IEEE802.3cg TF

Comments on draft

March 5^h 2018

Figure 147-2—PCS reference diagram

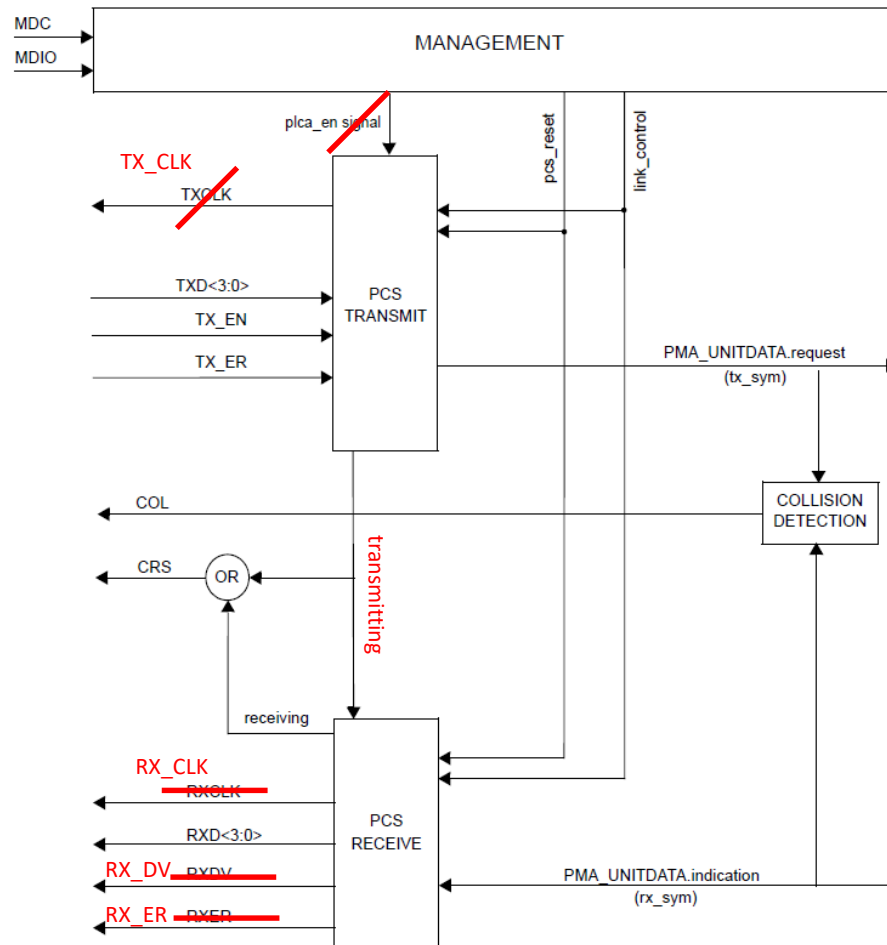
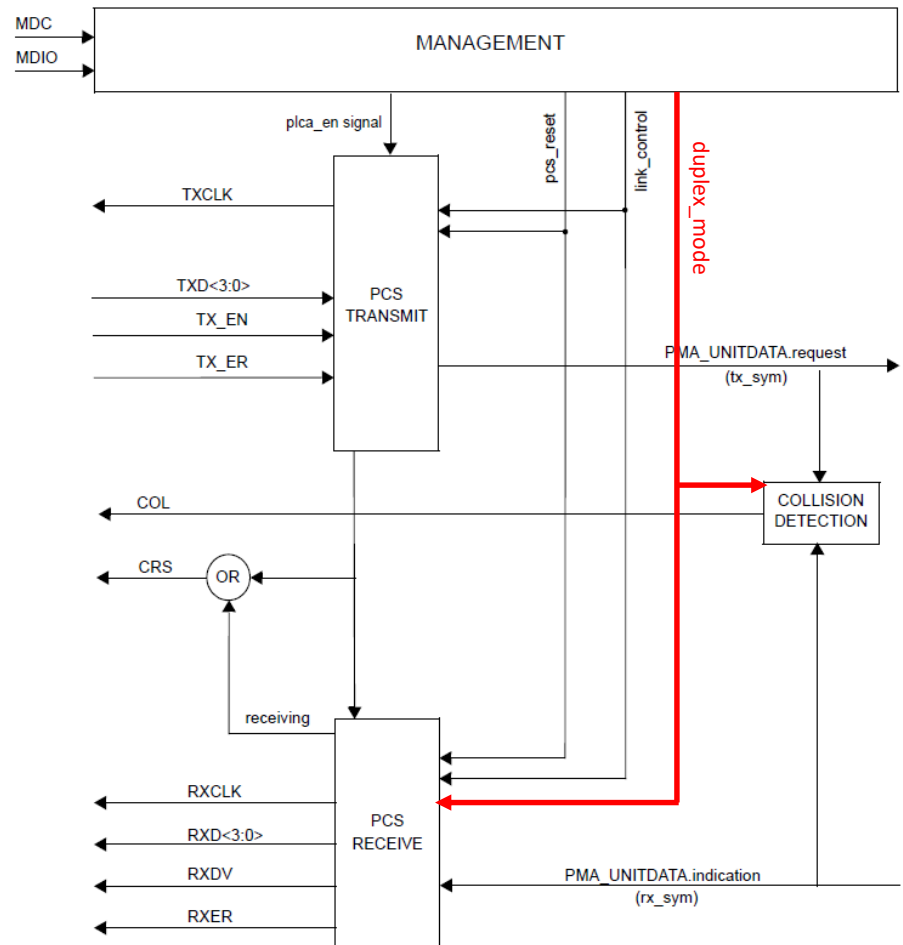
Collision detection shall be disabled when operating in full-duplex mode

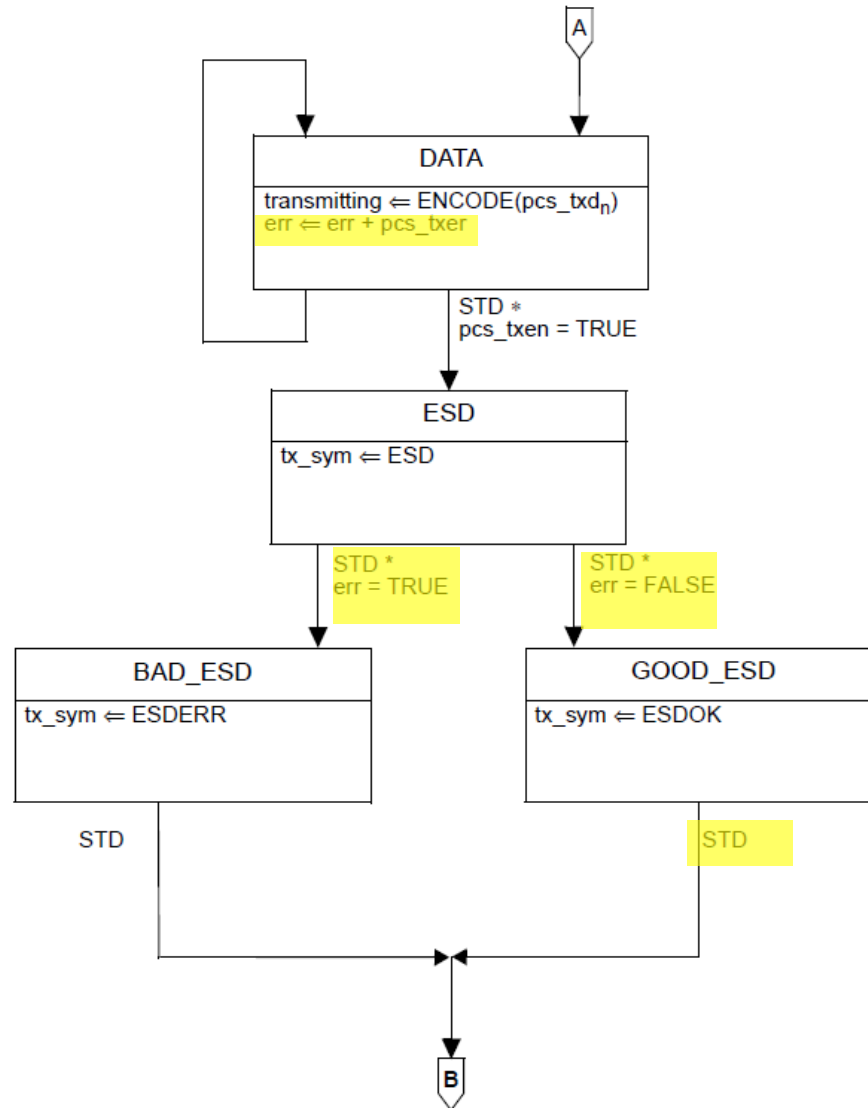
- In order to support full-duplex mode, the PCS RX block should be configured accordingly

147.2.3.1 Variables

`duplex_mode`

indicates whether the PHY is configured for full-duplex operation (`DUPLEX_FULL`) or half-duplex operation (`DUPLEX_HALF`). This variable is set after bit 8 in MDIO register 0 defined in table 22-7

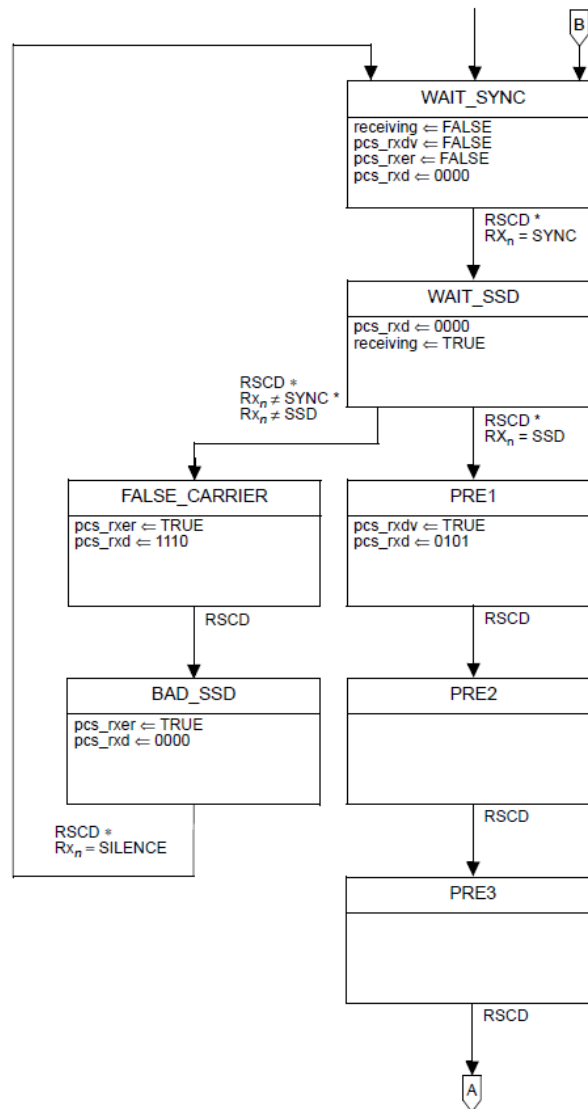
In order to support full-duplex mode, the PCS RX block should behave accordingly

(transmitting = TRUE * duplex_mode = DUPLEX_HALF)

pcs_reset = TRUE +
~~transmitting = TRUE +~~
link_control = FALSE

Figure 148-3—PLCA Control state diagram (part 1 of 2)

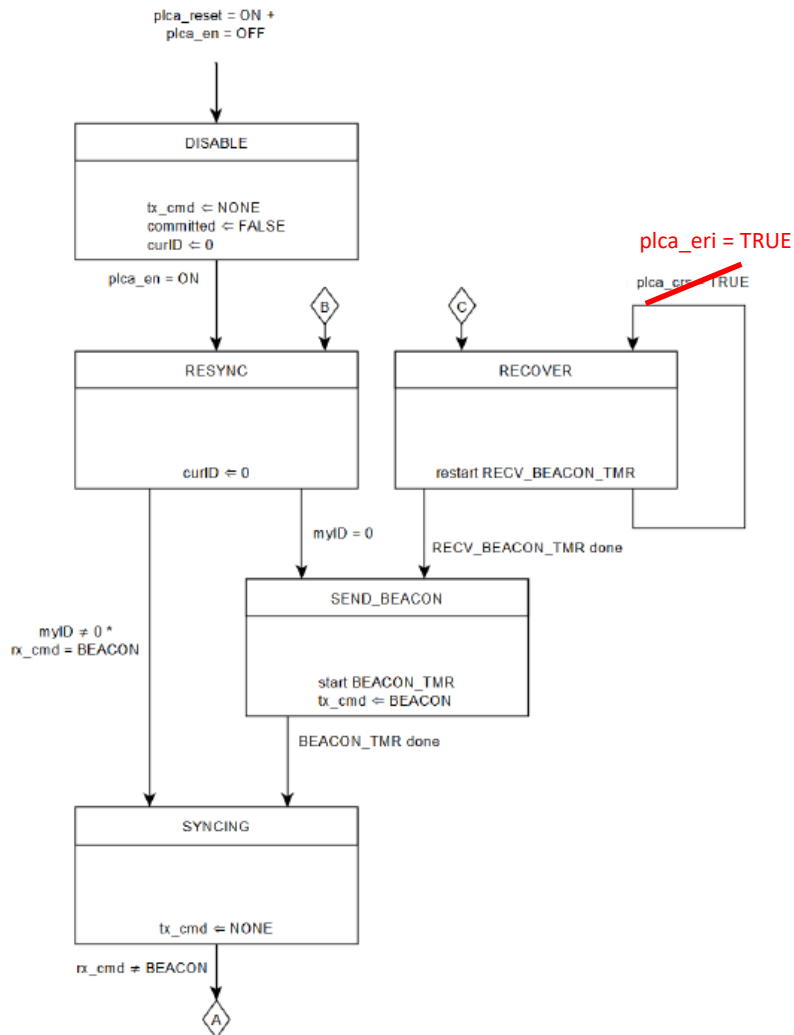
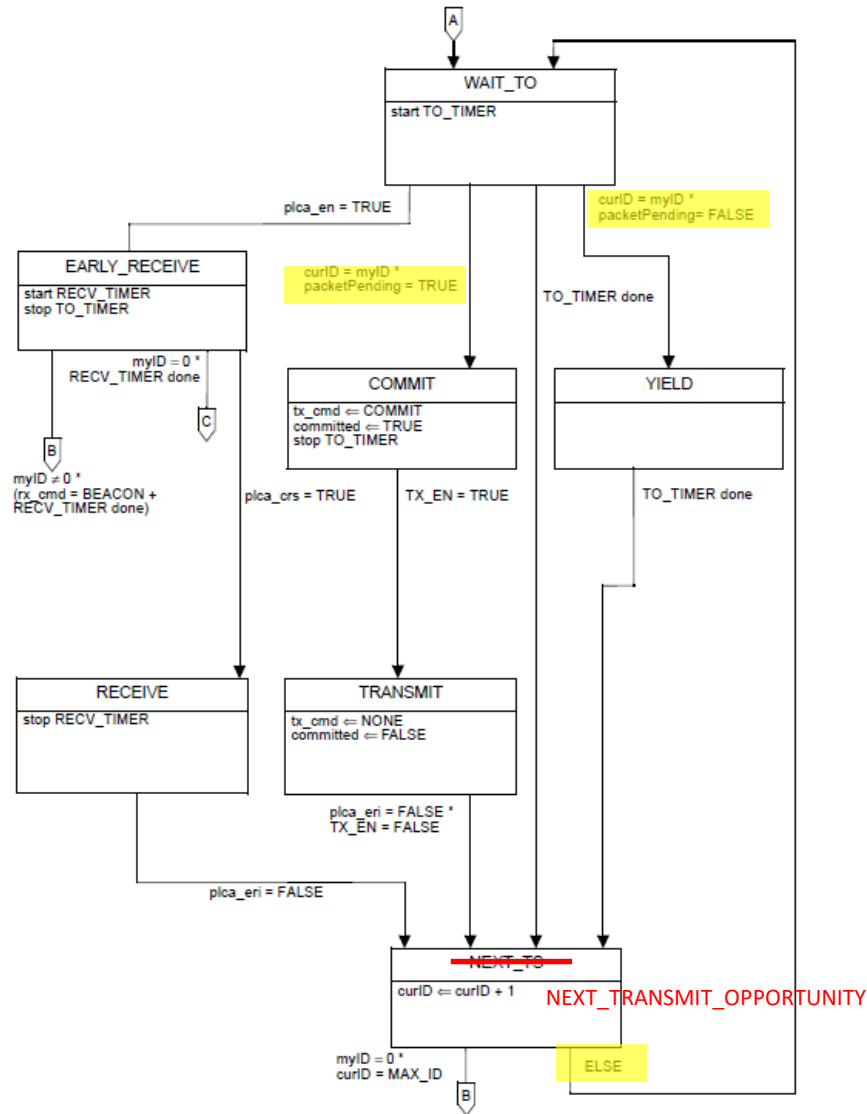
In figure 148-3, the transition from RECOVER state to RECOVER state should be done whenever some activity is sensed on the media ("plca_eri"), not only when a good receiving is ongoing ("plca_crs"). This to avoid collision when BEACON is sent

148.4.5.2:

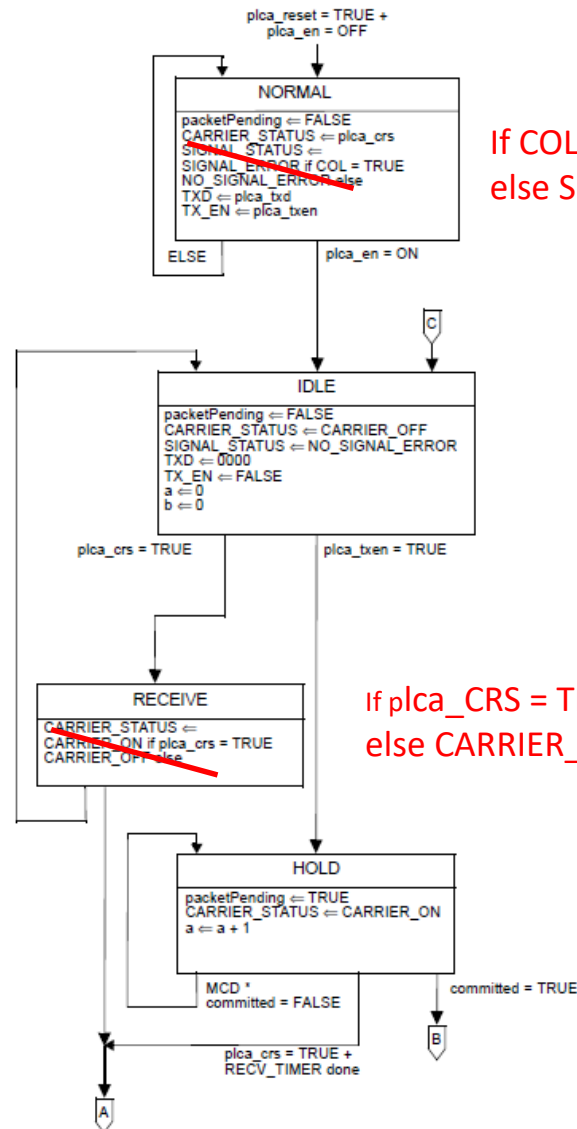
- **MAX_ID** can be left unconfigured on slave devices, myID shall not depend on it

Values: integer value from 0 (master) to ~~MAX_ID~~255.

Editorial: #127

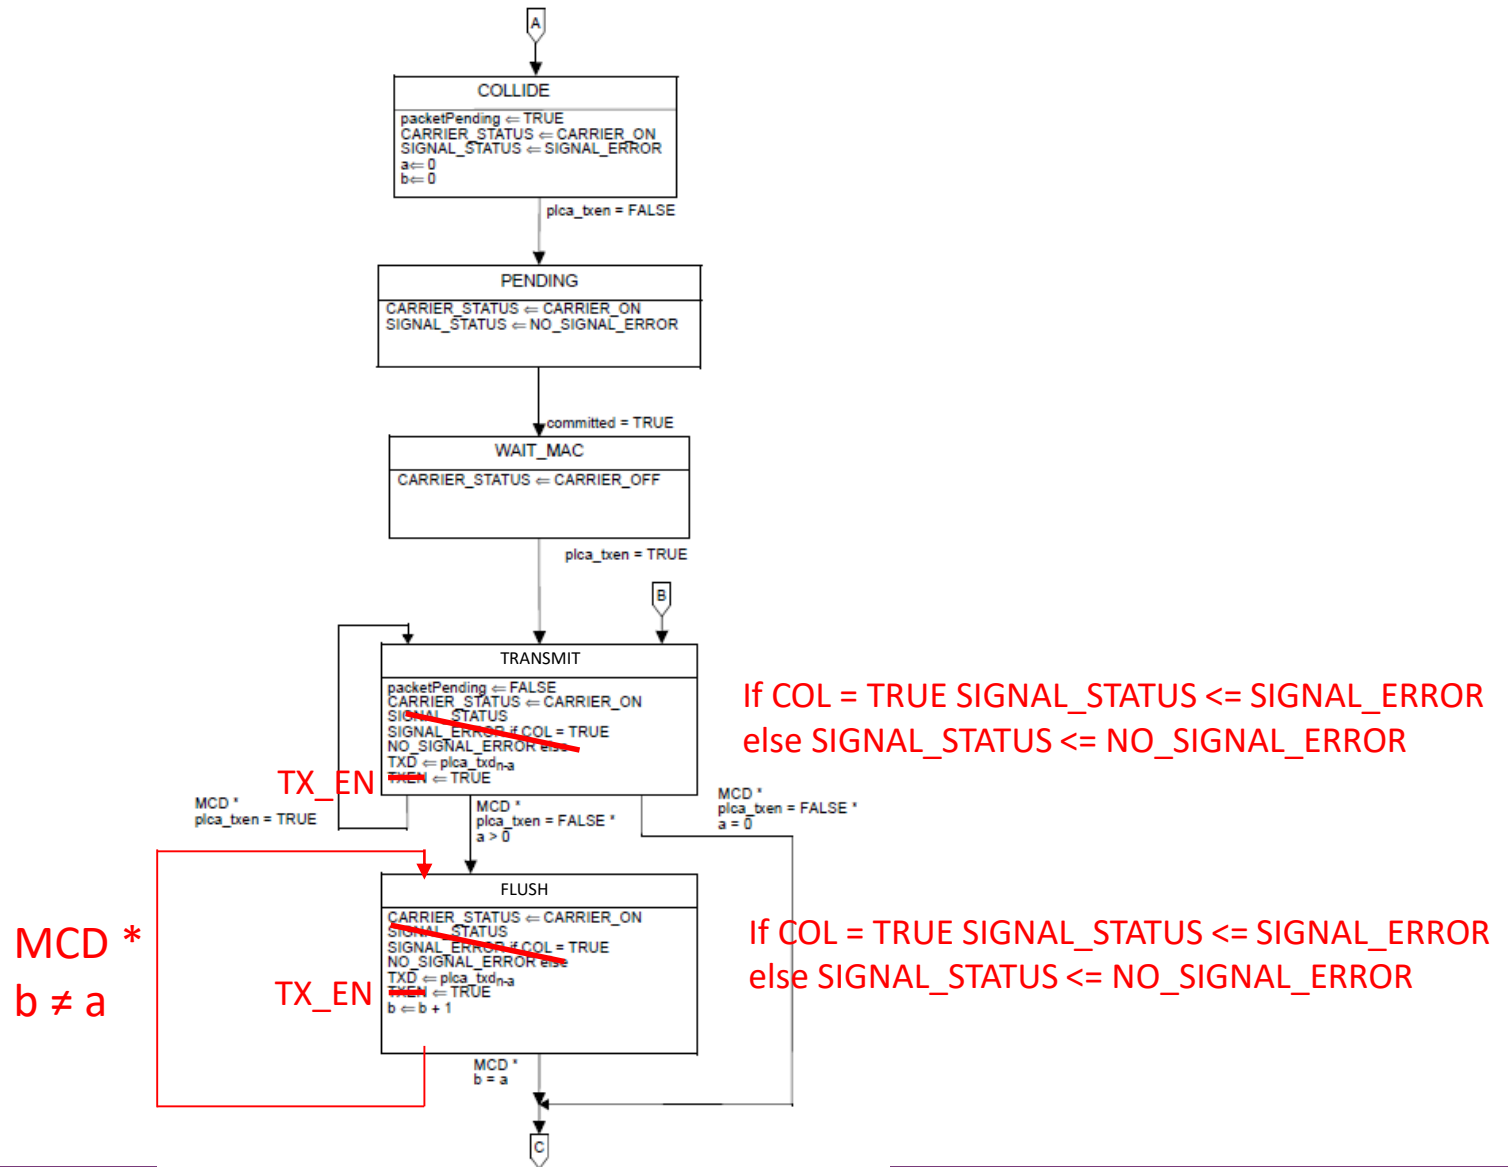
If COL = TRUE SIGNAL_STATUS <= SIGNAL_ERROR
else SIGNAL_STATUS <= NO_SIGNAL_ERROR

If plca_CRS = TRUE CARRIER_STATUS <= CARRIER_ON
else CARRIER_STATUS <= CARRIER_OFF"
